RE: Douglas 234 Filing 6 Lot 3 McDonalds Site Plan – Engineering 1st Review

Thank you for the comments on August 23, 2021 for the above-mentioned project. In an effort to address your comments concisely and simplify your review of the plans, we have summarized your comments and our responses below.

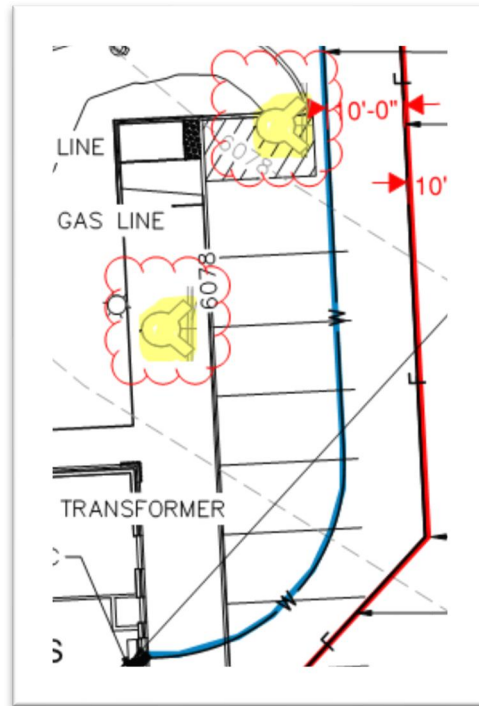
2. The applicant shall be aware that the access road hydrant distribution was not planned to address the suppression needs for all commercial properties within this subdivision; this site requires the addition of one hydrant (to be located at the s/w corner island of the building... as required per NFPA 24 Section 7.2.3... see the snap shot of the red-lined fire hydrant location shown under item 4 below:
 - *Response: A fire hydrant was provided.*

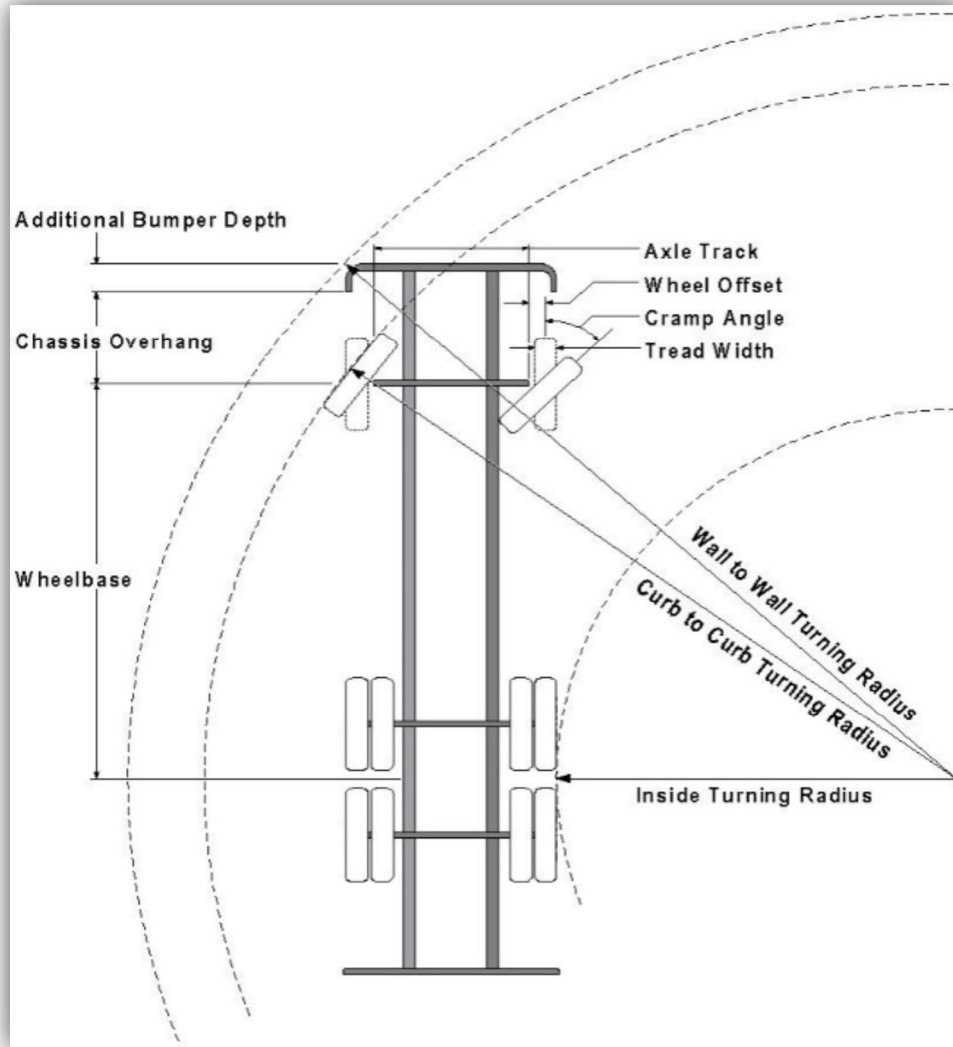
All fire hydrants shall be installed according to water utility standards. The number and locations of the fire hydrants as shown on the Overall Utility Plan are correct as specified by the Town of Parker, Community Development Department.

(NOTE - Underground Fire Line (UFL) submittal documents must meet the requirements of NFPA 24 when submitting for review.)

- *Response: Added to the Utility Plan.*
